Reevaluating Kosovo's Least Cost Electricity Option

Preliminary Evaluation of the World Bank's December, 2011 "Background Paper, Development and Evaluation of Power Supply Options for Kosovo"

Bruce C. Buckheit

January 2012

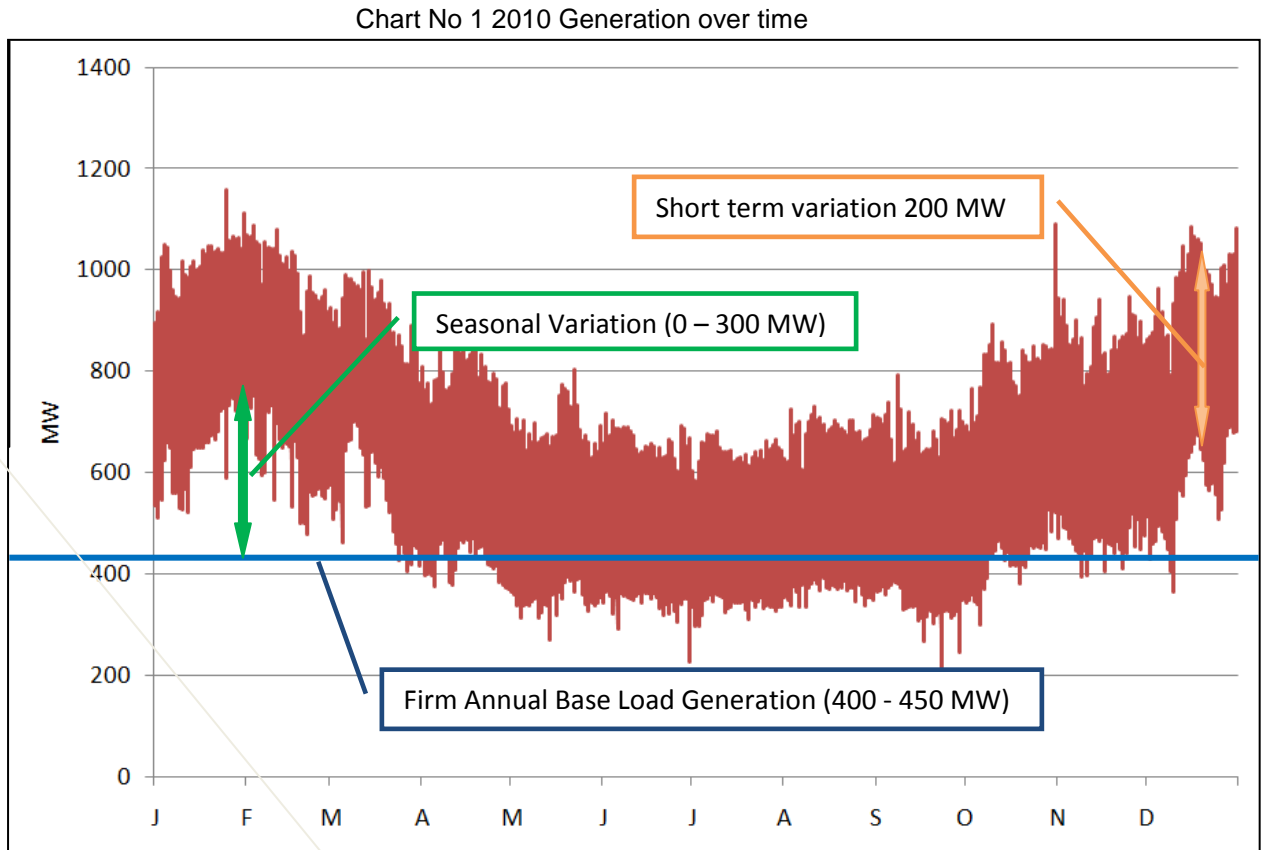
The WB Background Paper includes plots of electric consumption (including technical and nontechnical losses) for 2010. These plots are reproduced and annotated below.

Net consumption by consumers (residential and commercial) is reported in the WB Background Paper at 57 per cent of the amounts generated. Thus, the actual base load consumption (assuming no losses) in 2010 was met by 228 MW of generation. If the “distribution” losses are reduced from 17 percent to 5 percent and “commercial” losses similarly reduced from 24 percent to 5 percent (and assuming a price elasticity of -0.4) then net base load consumption rises by an equivalent of 11.4 MW (since those who had been getting “free” (i.e. stolen) or unmetered electricity would now pay for and consume 60 percent of the earlier amounts). However, net base load consumption rises to 80 per cent of firm base load net generation – and can be met by 320-340 MW of firm annual base load generation. Thus, if distribution and “commercial” losses are reduced to levels commonly experienced throughout the world, a refurbished Kosovo B (618 MW

A review of the current daily generation and demand forecast by KEK reveals that current needs for peaking generation are as suggested by the above data. Daily variations in demand are approximately 200MW. The hourly rate of change in demand in the morning and evening exceeds 50MW/hr which is largely met by purchased power (imports). The WB Background document reports that import prices for peaking power are up to €113/MWh and that imports are not available at some times of peak demand, leading to load shedding. This is consistent with pricing patterns in the United States. While the full distribution of hourly import prices has not been evaluated, it appears likely that the Zhur power plant (at the WB estimate of €96/MWh) is more cost effective than purchasing power to serve peak needs. However, the estimated annual capacity of Zhur is only about half of the peaking power needs of Kosovo and so some continued purchases or additional peaking generation capacity will likely be needed.

Chart No. 2 Cumulative Generation

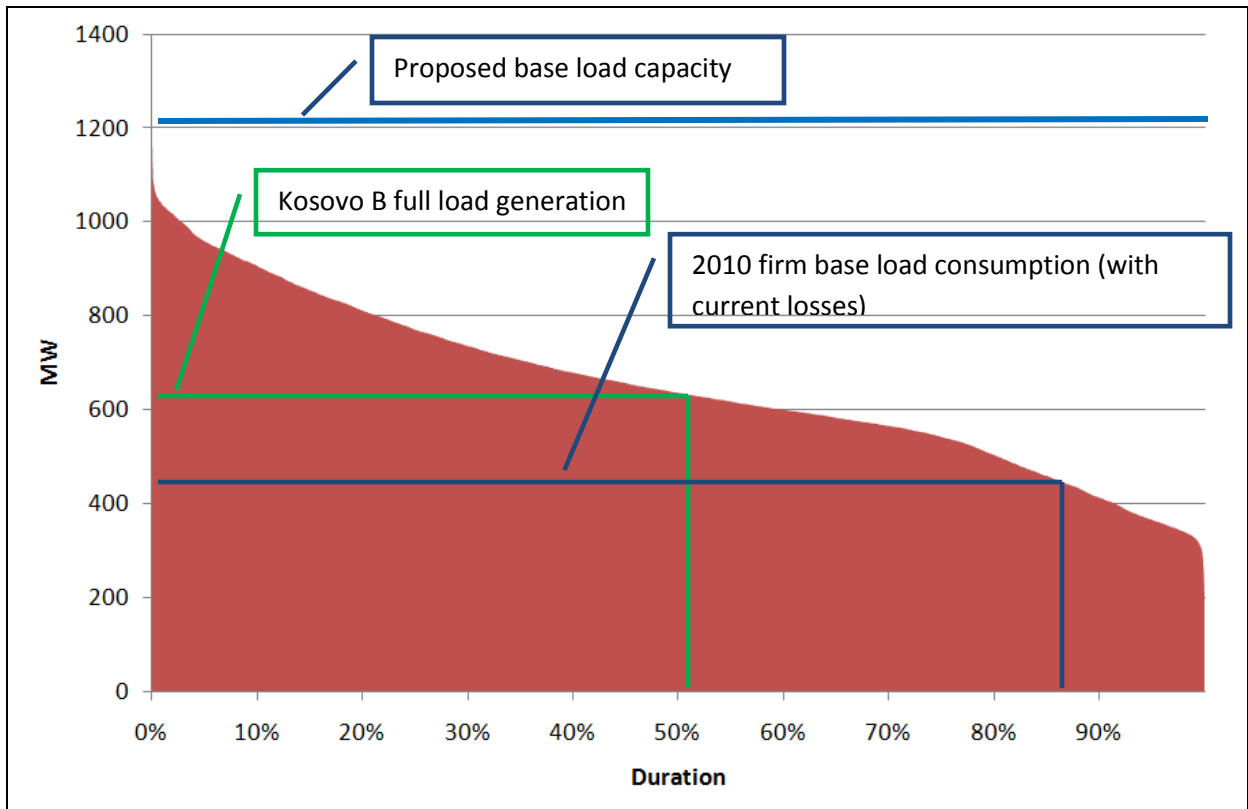
The data from Chart No. 2 shows that, with 2010 levels of technical losses and theft, the firm base load level⁶ was slightly above 400 MW and that the generation needed to meet demand (and cover losses) would have required full load operation of a refurbished Kosovo B plant only 50 percent of the time. If technical and non-technical losses are each reduced to five percent, the values of the vertical axis of the chart are reduced by 20 percent.⁷ The full base load need of the system is reduced to 340 MW and a refurbished Kosovo B plant would only need to operate at full load 20 percent of the time to meet this demand. If the full base load demand is assumed to grow by the high end suggested by the World Bank Background Paper (4.5 percent per annum), the

⁷ Since it is reasonable to assume that the reduction in losses is uniform across the load profile the shape of the curve should not vary significantly, but simply be reduced such that, where the vertical axis in Chart 2 reads 400 MW, it would become 320 MW and where the vertical axis of the Chart reads 800 MW, it would become 640 MW. The proposed base load capacity would remain at 1200 MW.
